SUBJECT: Nortek Global HVAC Furnace Service Bulletin

**TO:** Residential Distributors and Dealers  
**FROM:** Nortek Global HVAC Technical Support  
**DATE:** October 26, 2015  
**RE:** E4EB-015H, E4EB-017H

**REVISED**

Remove covers

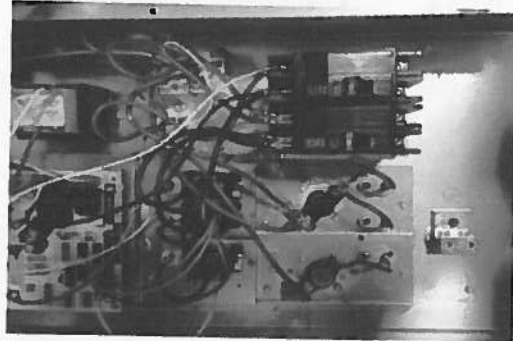
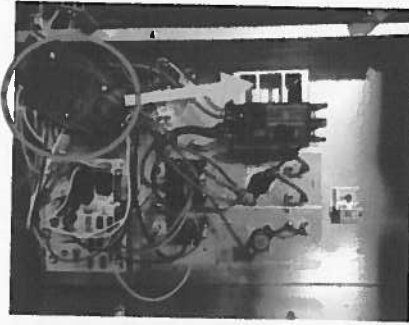
Nortek Global HVAC recently discovered an inconsistency between the label affixed to the breaker box cover and location of the breakers in E4EB-015H and E4EB-017H furnaces.

If the label is followed when connecting the branch circuit to the furnace, the breaker with the 10 kw heat bank could be wired to the 30 amp branch circuit breaker at the main electrical panel, and the 5kw heat strip and blower could be wired to the 60 amp branch circuit at the main electrical panel.

While this does not present a safety issue, when the 10KW heat kit bank energizes, it will trip the 30 amp branch circuit breaker. The furnace will continue to operate with only 5KW of heat.

1. At the main breaker panel, identify the 2 double pole breakers supplying power to the furnace and switch them to the off position
2. Remove the door from the furnace.
3. Remove the control doors covering the heater elements and breakers.
